Environmental Minor Project Refinement Form

Project Name: West of Devers Upgrade Project Request Prepared By: Sylvia Granados

Date Approval Required: 4/11/2018 Variance Request No.: 10

New Work Area Required for Mountain View Material Yard Driveway and Temporary Power Conveyance

FIGURE 2-1

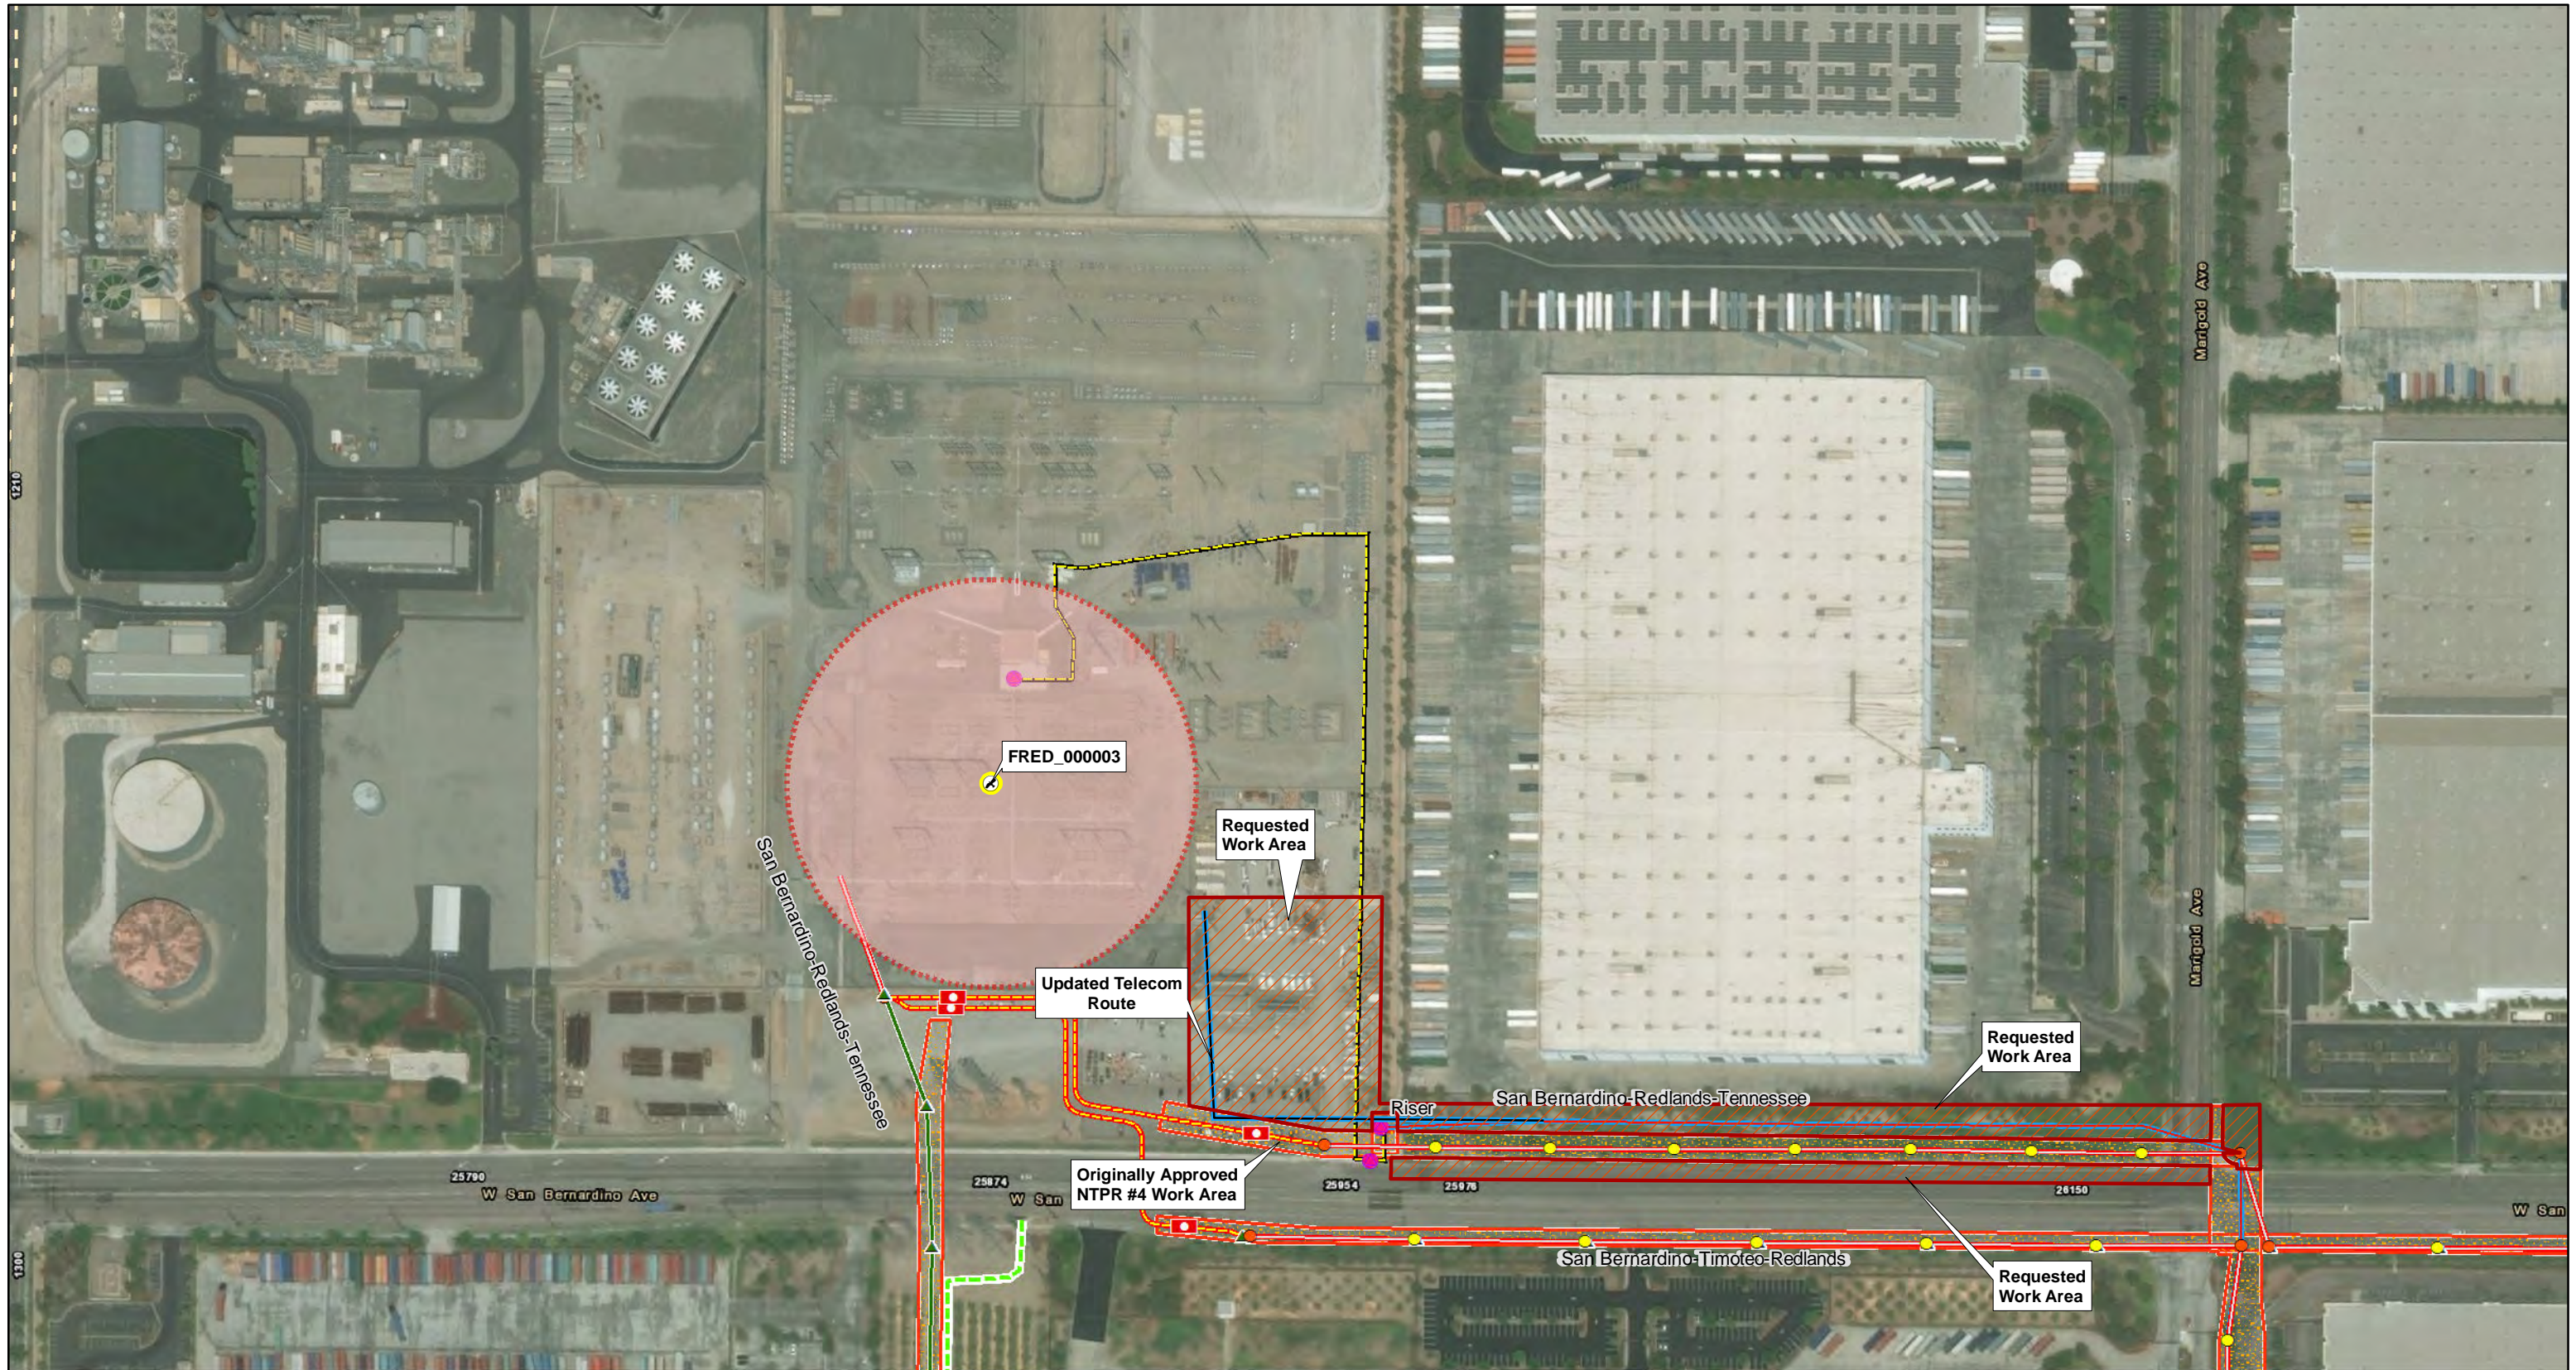
The frontage area of the Mountain View Material Yard will be used to expand the existing driveway for material yard deliveries and to provide temporary power to the yard from an existing pole on Mountain View Avenue. The dimensions of the new work area are approximately 60 feet by 110 feet. The material yard front gate will be widened to 30 feet and the driveway approach to the gate will taper from 30 feet at the gate, down to the existing 18-foot driveway width at the existing curb. The existing curb and gutter will not be modified. The broken pavement and subbase on the existing 14-foot driveway will be replaced with Class II aggregate base, in accordance with City standards and approvals.

The new work area will also be used to stage material and equipment during the installation of temporary power from the existing power pole on Mountain View Avenue. Only drive and crush impacts to the previously disturbed area are required for the installations.

The City has approved the driveway widening from the existing edge of curb into the material yard and the use of the area for power conveyance.

The temporary impacts to developed/disturbed land are 0.27 acre.

FIGURE 2-2
Page 1 of 2

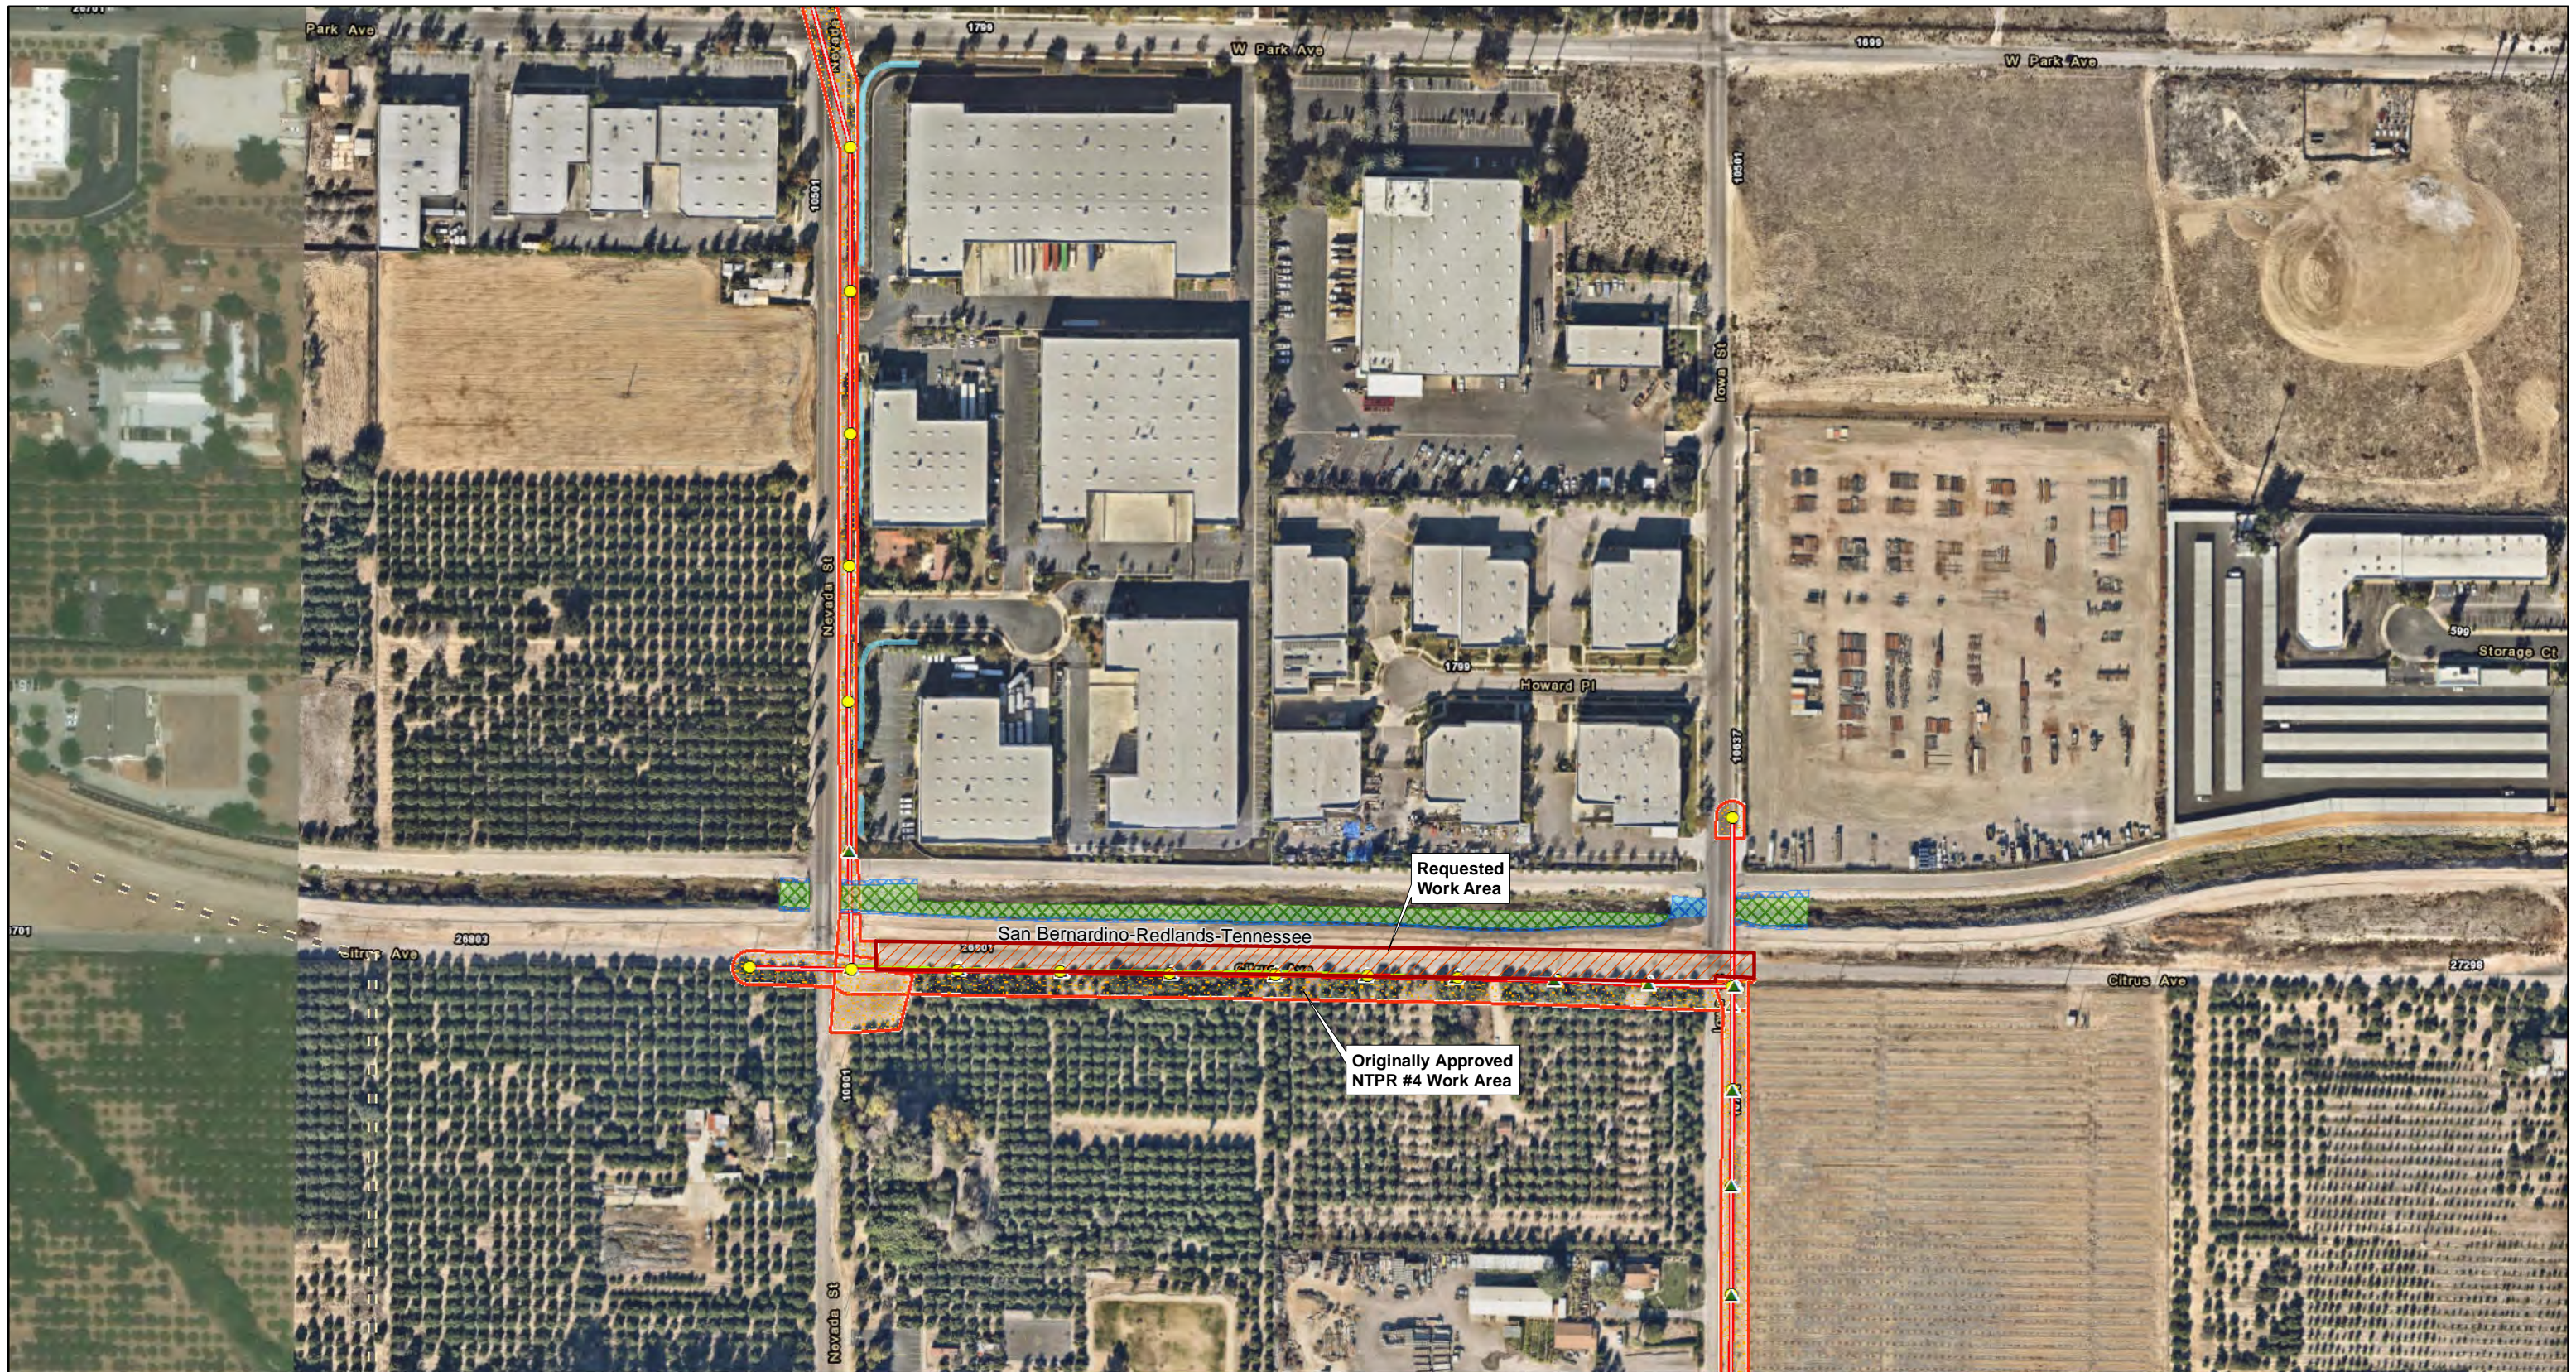
North side of San Bernardino Avenue east of San Bernardino Substation to Marigold Avenue, in Redlands

An approximately 300-foot by 350-foot work area is required for material and equipment staging and construction of telecom route improvements east of the San Bernardino Substation, extending along the west and south sides of the new work area, as shown on Figure 2-2, page 1.

An approximately 1,250-foot by 130-foot work area is required for material and equipment staging and construction of telecom route improvements east of the San Bernardino Substation, extending along the north side of San Bernardino Avenue to Marigold Avenue, as shown on Figure 2-2, page 1.

The temporary impacts to developed/disturbed land are 4.31 acres.

FIGURE 2-2
Page 2 of 2

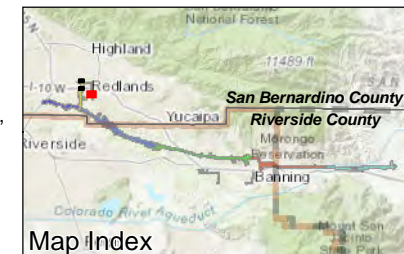
South side of Citrus Avenue, from Nevada Street to Iowa Street

An approximately 1,250-foot by 50-foot work area is required for material and equipment staging and construction of subtransmission route stringing improvements along the south side of Citrus Avenue from Nevada Street to Iowa Street, as shown on Figure 2-2, page 2.

The temporary impacts to developed/disturbed land are 1.24 acres.
